Lab-response to PBA 345953

FCC-ID: NM8SPRR - TC312546 - PCE

Because of the relatively high SAR levels reported, we would like clarification on several issues in the SAR report:

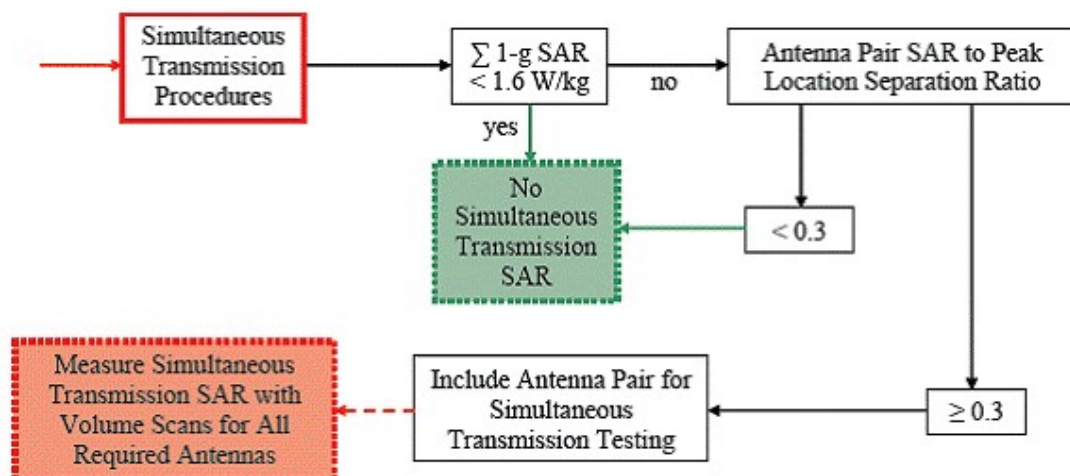
1) It is assumed that cosmetic changes are being made to the case when the various *solutions* are mentioned on pages 4-5, but the provided description and photos are not clear with regard to button changes. What button is being changed? What is the reference to 20% deviation? There also needs to be information provided on the multi-slot mode of the device.

[SGS response] The description of changes of EUT (different solution) is further explained in the revised report. Solution 2 is actually change the LCD module and camera, Solution 3 changes metal plated button, and black-color housing from original, Solution 4 changes LCD module and camera from Solution 3. The reference 20% deviation is basically SAR dosimetric equipment uncertainty, If the deviation over this 20% limit, then we should treat it as “RF performance is changed”.

Since there is no visible difference from external view, we can only tell the difference by customer's declaration.

Customer changes the LCD module to a second source, the product spec are the same, but supplier are different.

We indeed take the photo for the original solution and second solution (so is the third solution and fourth solution)

But, we're unable to show it by photo.
